INDEPENDENT EXPERT ADVISORY PANEL FOR MINING

CHAIN VALLEY CONSOLIDATION PROJECT (SSD-17017460)

GREENHOUSE GAS ASSESSMENT

Advice No: IEAPM 202401-1

Figure 1: An example of a relationship between gas make and coal mined for the “active mining area”

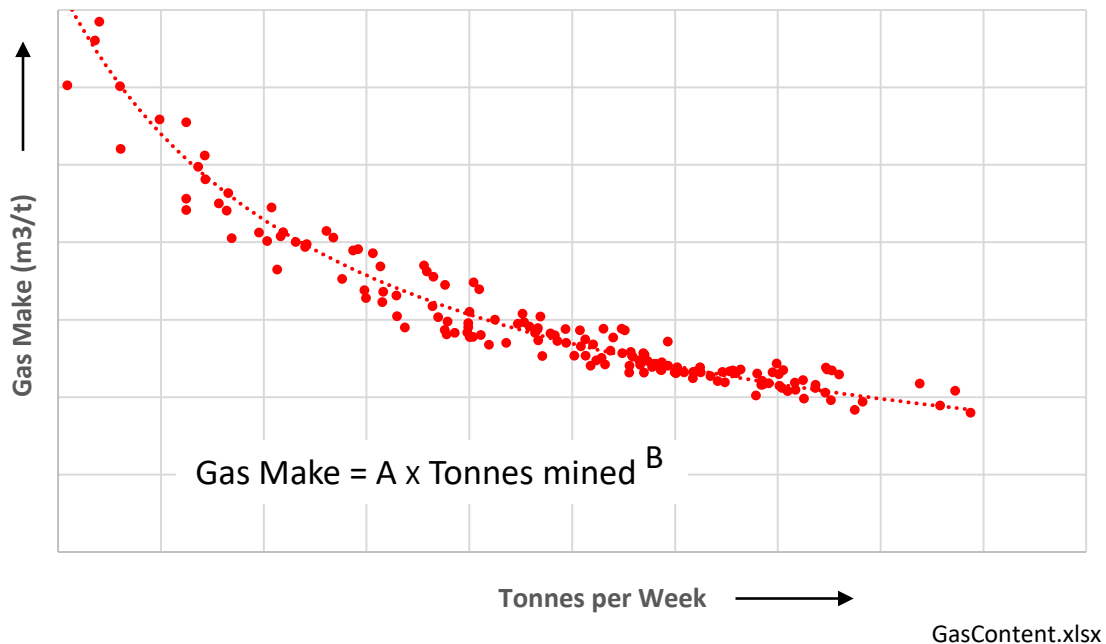
The gas make curve needs to be defined for each active mining panel. The gas make is assigned from the gas make equation (example Figure 1**Error! Reference source not found.**) for the average weekly production of the area in question.

Figure 2: Gas Content Sample Locations from the Fassifern Seam, Chain Valley Colliery.

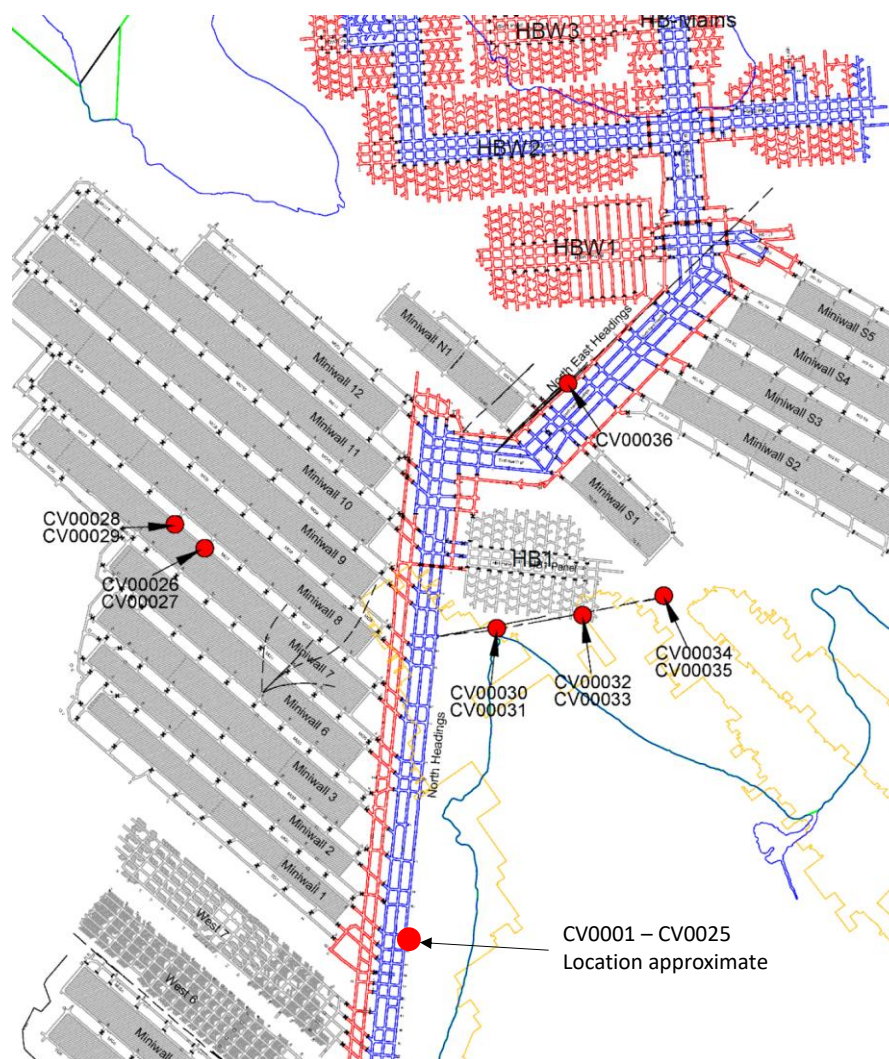
The Fassifern Seam in situ gas content value of 5.3 m³/t at 97% CH₄ and 3% CO₂ is central to Umwelt's forward assessment. It appears to be the result of gas content testing from sample CV0036, the most recent and highest value from testing of the Fassifern seam (see Figure 2 and Table 1).

While these data are high quality, there is a tendency to sample lower ash coal than is typical for the seam as a whole. For example, sample CV0036 with a gas content of 5.29 m³/t has a corresponding ash of 12.9%. The full seam at this location has an ash of 23.4%⁸. To correctly apply a gas content value, it must be corrected to the ash (or relative density RD) of the region of interest. Correcting the 5.29 m³/t gas content to 23.4% gives a value of 4.64 m³/t (see Figure 3).

Figure 4: Proposed mining regions in the Fassifern Seam

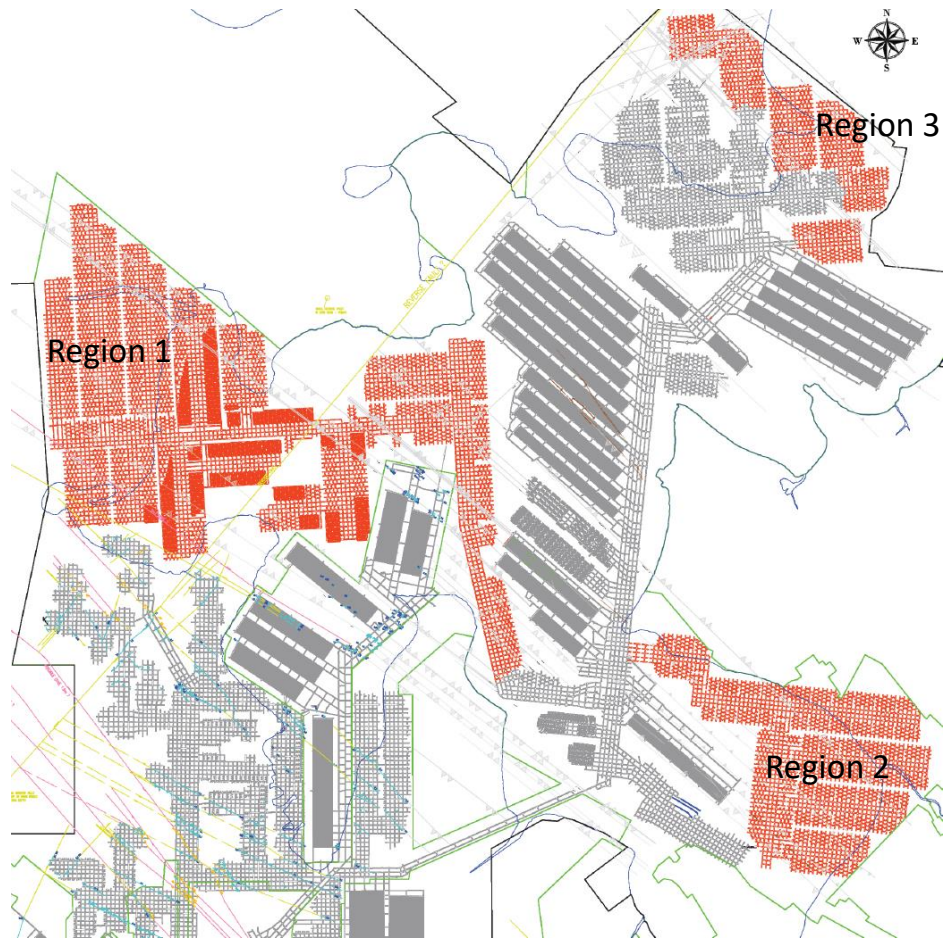
Three regions (1 to 3 in Figure 4) are proposed to be mined in the Fassifern Seam. For each region⁹, the gas content, seam ash, relative density (RD) and seam thickness can be defined.

With zero depth below the Fassifern Seam and at the seam ash at the borehole location (22.2%), the calculated gas content is 2.9 m³/t. It appears Region 2 may have a significantly lower gas content than Regions 1 and 3. Further gas content testing should be done to better define these regions.

Figure 5: Measured and calculated gas content for borehole drilled below the Fassifern Seam

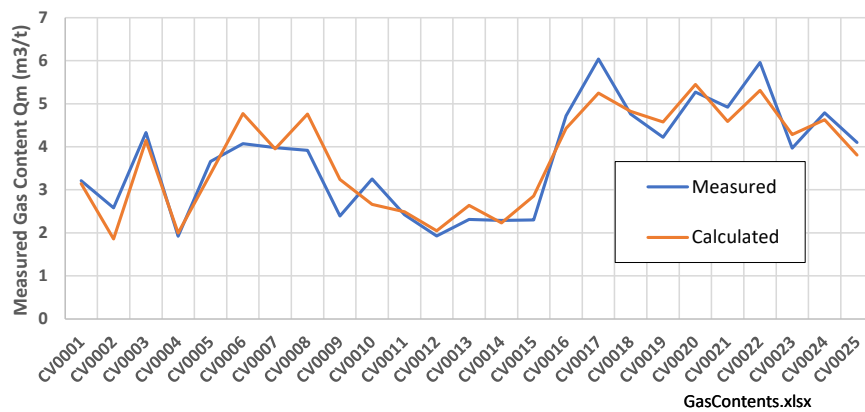
Data from the borehole drilled below the Fassifern seam (CV0001 to CV0025) are potentially usable. It shows a consistent change with ash and depth along the borehole below the Fassifern Seam (see Figure 5).¹¹
